Plan Commission

Revised Agenda

Monday, January 8, 2018

SUBJECT: Recommendation regarding a Site Plan for a new commercial building and parking area called ALDI at 1030 Main Avenue (All of Parcel WD-VA454 and part of Parcels WD-VA-450, WD-VA450-1, WD-VA455-1). Submitted by Garritt R. Bader, Principal, GB Real Estate Inv. LLC.

© COPYRIGHT 2016

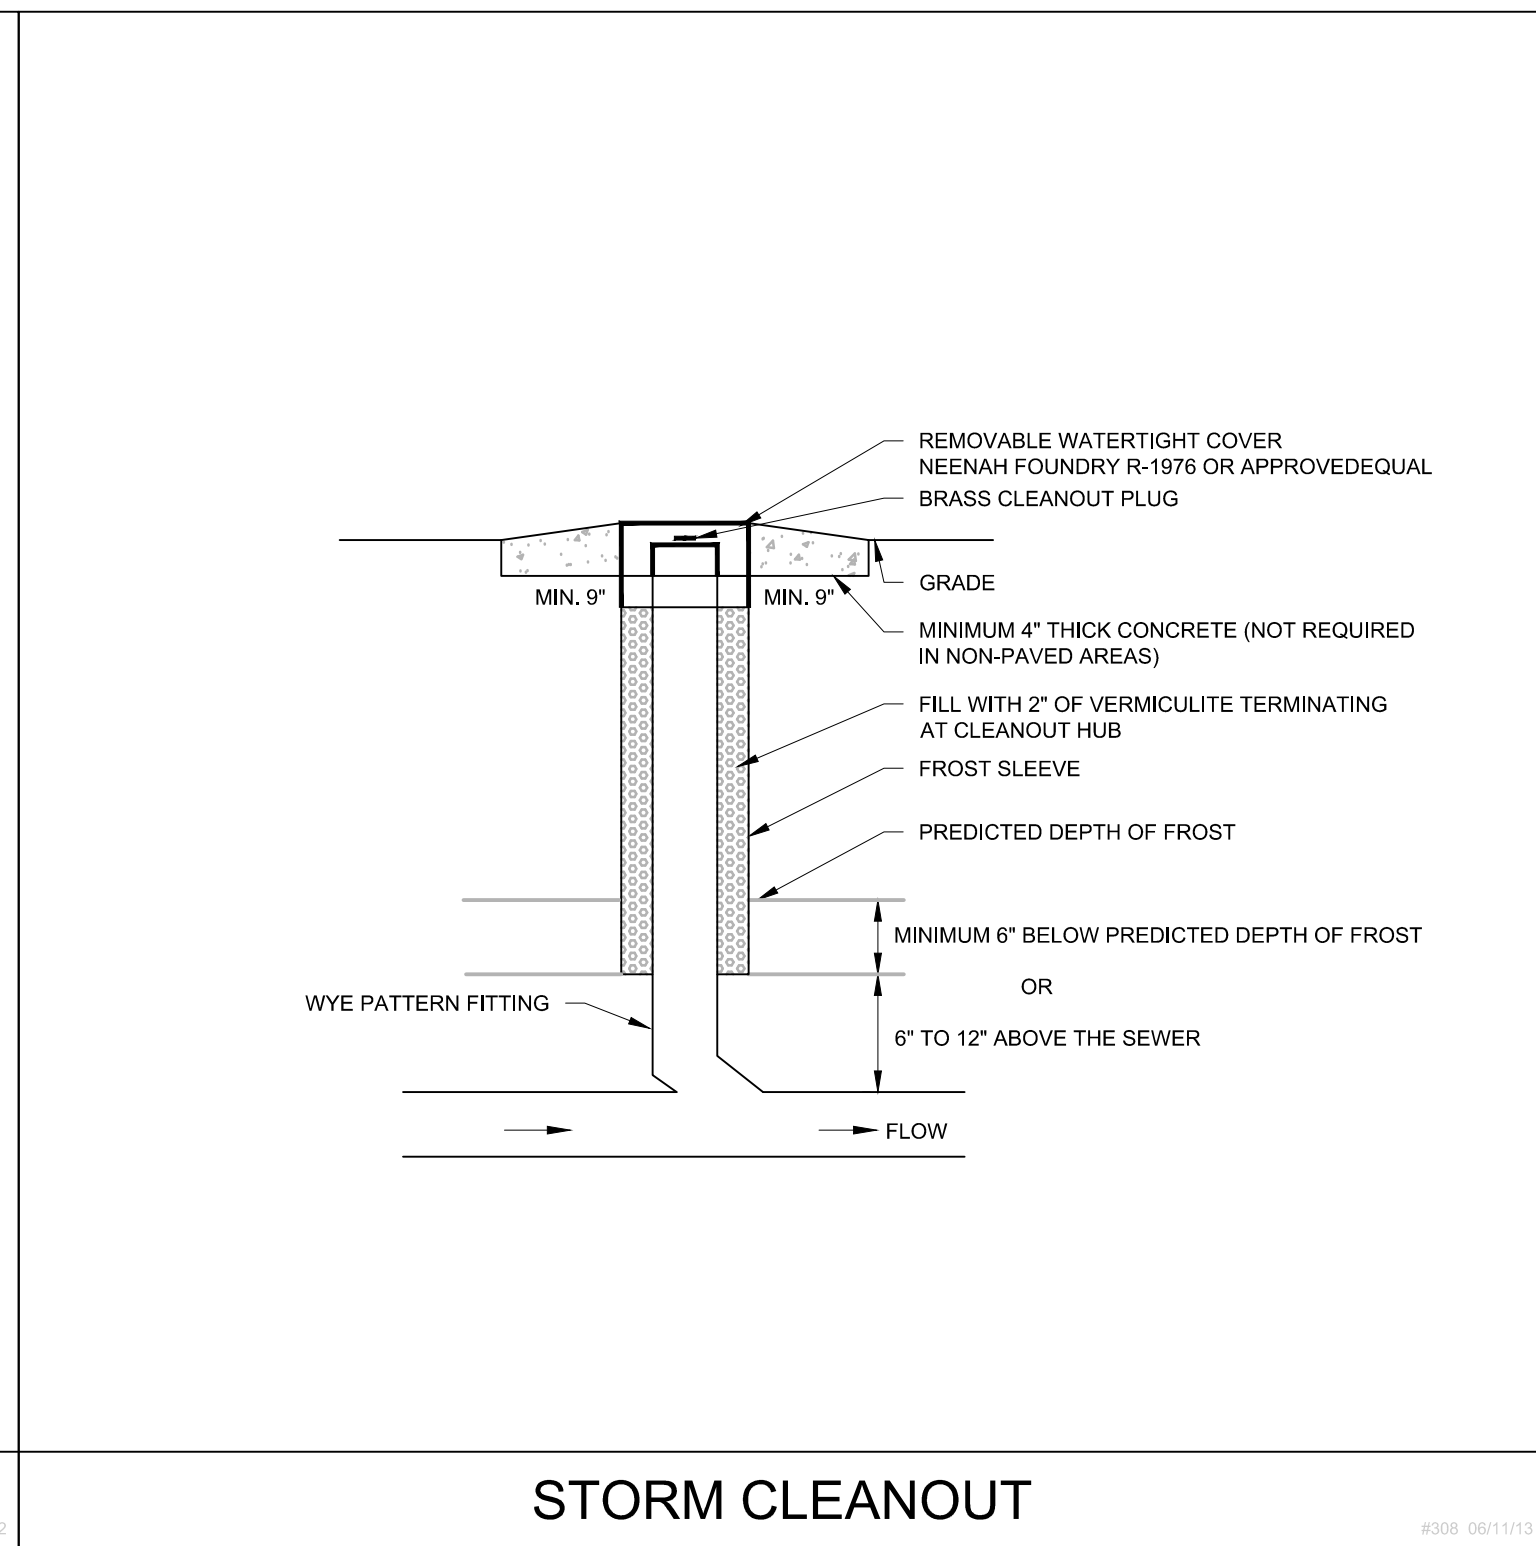
8. On Sheet C-6 the elevation given for the top of the sanitary lateral pipe for crossing three leaves the pipe below the anticipated sanitary stub invert listed on the same sheet. $603.49 - 0.5 = 602.99$, which is below 603.08.
